We thank the reviewers for their extensive comments. Below are our answers (in red). Modifications to the manuscript are indicated below. We hope these answers clarify the motivation and choices made in this work and hope that the manuscript can be published in Ocean Science.

Reviewer 1 (Wittekind):

Figure 1 Source levels for a 15 000 DWT General Cargo vessel with 4-stroke engine and a FP propeller at design speed of 14.5 knots.

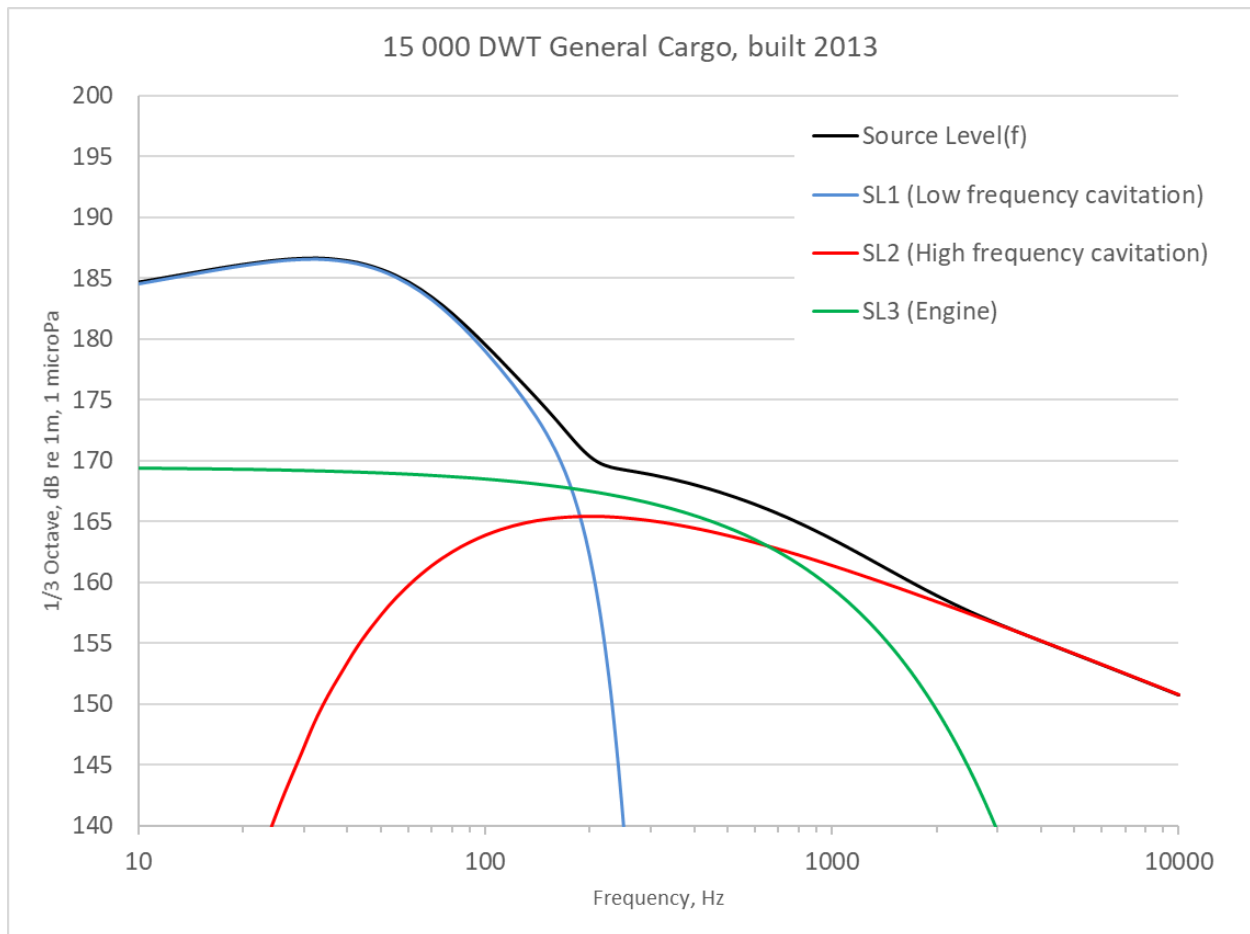
Could the authors add a graph showing the output (source level) of the Wittekind model for 2 or three typical ships?

Below is a collection of noise source graphs for various kinds of ships. Figure 1 represents a general cargo vessel with a 4-stroke engine and a single propeller. Figures 2a-b and 3a-b respond to the previous question of the referee concerning the engine mounting parameter selection. Figure 4-5 contain two examples of RoPaxes with more than one propeller. One of the test cases (Figure 4) represents a vessel type which is equipped with two electric propulsion units and four diesel generators to indicate the extreme case of a multi-engine, two propeller case with diesel-electric propulsion.

We have added these five noise source cases (in seven images) to Supplementary material. These illustrate the form of the noise source curves as a function of frequency using the approach described in this paper as well as the impact of using rigid/resilient mounting for engines.

Figure 2 a and b. Noise source levels for a 1500 TEU Container feeder vessel with a 2-stroke engine and a FP propeller assuming flexible mounting (a, left) and rigid mounting (b, right). Vessel traveling at design speed of 19.8 knots

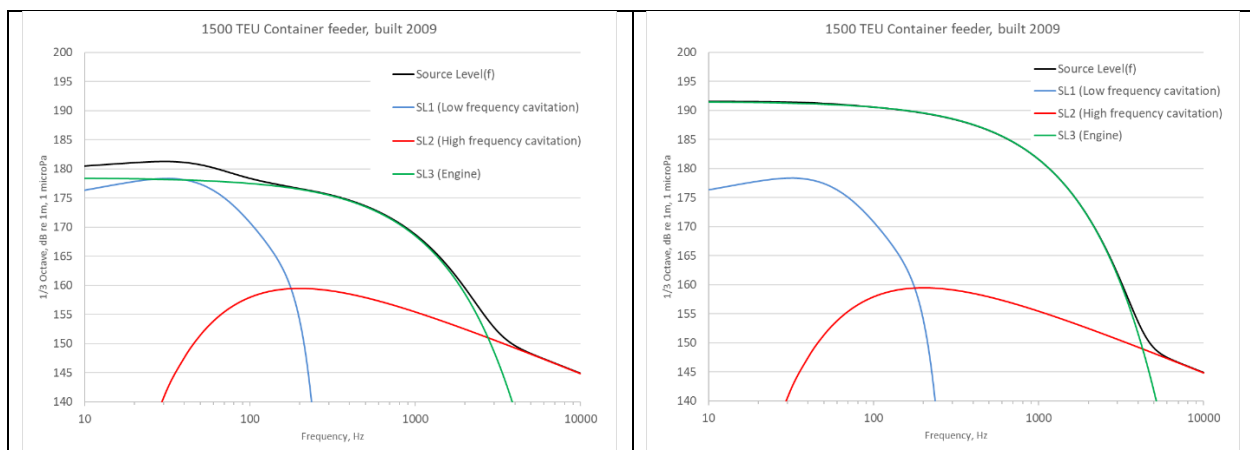
The Wittekind model only considers 4-stroke engines be it for propulsion or as auxiliary diesels. 2-stroke engines are observed to have similar under water levels as resiliently mounted 4-stroke engines. If a heavy 2-stroke engine is taken as rigid mounted but with the same power-weightnoise relationship, diesel engine noise would be grossly overestimated. I do not think that the above remarks if entered into the map would change very much but I recommend checking what the allegedly overestimated contribution of the 2-stroke engines may do to it.

Supplementary Material Figs S8a and S8b illustrate the impact of flexible/rigid mounting, pointed out by the referee, for a feeder container vessel (1500 TEU). This vessel operates a single 2-stroke engine and has a FP propeller. Indeed, as the referee pointed out in his comment, a large difference exists in Source Levels because of engine mounting. Assuming rigid mounting makes machinery noise the dominating component of noise up to 6 kHz in this example. This specific vessel uses MAN S50MC-C series engine and according to the project guide of the engine, installation on epoxy or cast-iron chocks is required.

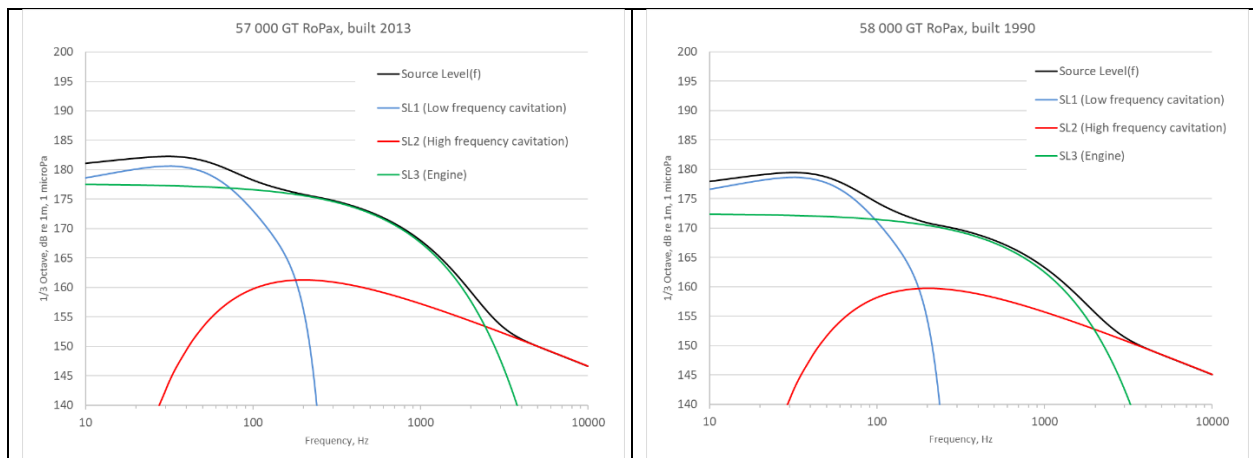
The Wittekind model is valid for single screw ships only. Twin screw ships have in general lower propeller loading and a more homogenous wake field and therefore higher CIS. That is likely the reason that cruise liners and other twin screw ships appear quieter. Cruise vessels have CIS well above the mentioned 14 knots where diesel engine noise clearly prevails such that even if the propellers did cavitate they would be masked by diesel noise

We thank the referee for the comments. The Baltic Sea fleet mostly consists of vessels with a single propeller. About 10% of the fleet operating in the Baltic Sea during 2015 has more than one propeller. Usually RoRo, RoPax, Cruise and icebreaker vessels normally use multiple propellers. If passenger vessels were given a higher CIS value in the model, it would make their contribution to noise energy smaller than what is presented in this paper. Conclusions of most significant shipping noise sources of this paper would remain unaffected. We tested the Wittekind formulas for RoPax vessels and indeed, the machinery part contribution may exceed the low frequency cavitation.

Figure 5 Predicted source levels of a medium size bulk carrier

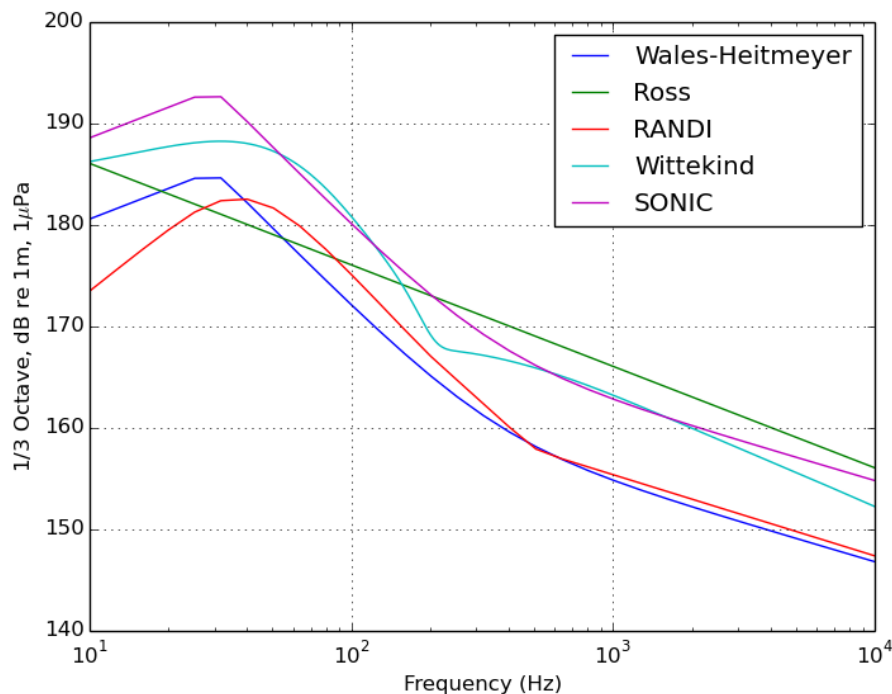
Farcas: It would be useful to compare or at least comment of the differences between the Wittekind source model used here and other models previously used in literature. For example, many shipping noise mapping methodologies might be based on the old Ross (1976) model that uses only the vessel speed and length to estimate the source levels of individual ships. Of course, a meaningful assessment would ultimately require a comparison of the noise maps based on the two source models and their statistical analysis; but even a comparison based on the noise source maps as produced by the methodology presented here might provide useful insights into the merits of using a more sophisticated source model.

In the beginning of the current work, a review was made to consider various noise models available in the literature. The Wittekind noise model was selected because of its performance against available measurements and its technical features improve the knowledge of individual contributions to vessel noise. From practical point of view, the significance of the availability of data to implement the model selected cannot be overlooked. Below is a comparison of investigated models; these are from existing literature (Ross, W-H, RANDI) as well a more recent one (SONIC) from on-going work of the institutes involved also in this study. As can be seen from this figure, the Ross model fails to reproduce the low frequency hump observed in noise measurements. Also, application of a 40-year-old model to current fleet raises some questions of its suitability, especially if the model considered relies on base spectra obtained with confidential measurements done after the WWII.

Of all the investigated models in this case, the Ross model predicts the highest source levels in the >2 kHz range, whereas low frequency contribution is clearly smaller than with most of the other models considered. The SONIC approach uses Wales-Heitmeyer approach as base spectrum and these two models are somewhat interlinked. However, the other approaches were much more limited in the technical description of vessels than what was available for the current work. Our selection of the Wittekind noise model was considered the best fit considering the performance, available data and quantities available from the existing emission model (STEAM).

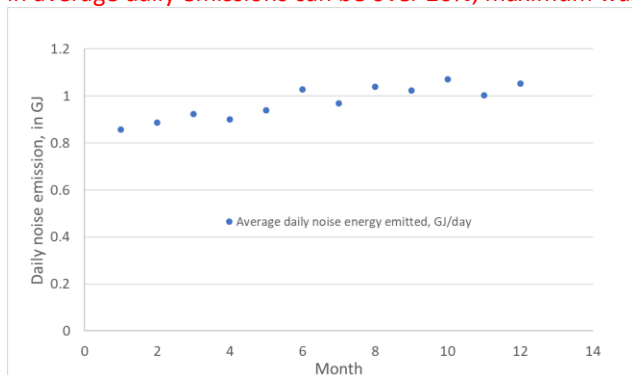
* Farcas: The finding related to containerships (that they are responsible for 25% of the noise energy) is quite interesting, but I'm not sure what is meant by them representing "about three percent of the ships in the Baltic Sea during 2015" – is this 3% of the total number of ships ever reported in 2015 in the area? Is the disproportionately high contribution of containerships to the total noise energy due to e.g. the greater number of "active" days per ship in this category than for ships in other categories (that might have been present or active only sporadically during the year), or perhaps this is due to more subtle factors related to source characteristics of containerships?

We fixed a spreadsheet error and updated Figure 4 to better reflect the issue raised by the reviewer. We introduced a new metric, noise efficiency, which is analogous to energy efficiency. This quantity describes noise energy emitted per distance travelled and amount of cargo carried. The unit is millijoules $\text{ton}^{-1} \text{ km}^{-1}$. This metric takes the amount of cargo carried into consideration in a similar manner as the IMO Energy Efficiency Operation Index (EEOI).

"Plotting noise energy emitted by each ship type as relative to total noise energy emitted at each band indicates that containership and bulk cargo carriers are the two largest sources of underwater shipping noise in the Baltic Sea area. Containerships represent less than three percent from all ships, but are

responsible for 27 % of the noise emitted at 125 Hz band. Bulk cargo carriers also have high share of noise emissions, but bulkers represent a significantly larger share from total numbers of ships (8%). (Error! Reference source not found.Error! Reference source not found.; Error! Reference source not found.). Analogous to energy efficiency metrics, reported in grams of CO₂ emitted per amount of cargo carried and distance travelled (in g ton⁻¹ km⁻¹), the emitted noise energy should also be compared to transport work or distance travelled. If done this way, containerships represent 15% of the transport work and emit 23% of the noise energy (sum of noise energy emitted at 63, 125 and 2000 Hz bands). In case of bulk cargo ships, the share of noise energy emissions is 23% and share of the transport work done is 21%. Considering the large share of transport work, bulk and general cargo ships emit less noise than containerships. The largest discrepancies between noise energy emitted and distance travelled occur with RoPax vessels, which are responsible for three percent of the transport work and contribute nine percent of the noise energy (sum of energy over all three bands) emitted in the Baltic Sea area. If noise efficiency is defined as joules of noise energy emitted for each ton km of cargo carried, noise efficiency in mJ ton⁻¹ km⁻¹ is very high for RoPax vessels (920 millijoules ton⁻¹ km⁻¹) whereas for containerships and bulkers these are 491 and 360 mJ ton⁻¹ km⁻¹, respectively. With this metrics, best noise efficiency is achieved with slow moving vessels, like general cargo carriers and crude oil tankers, which emit less than 200 millijoules of noise energy per ton km carried”
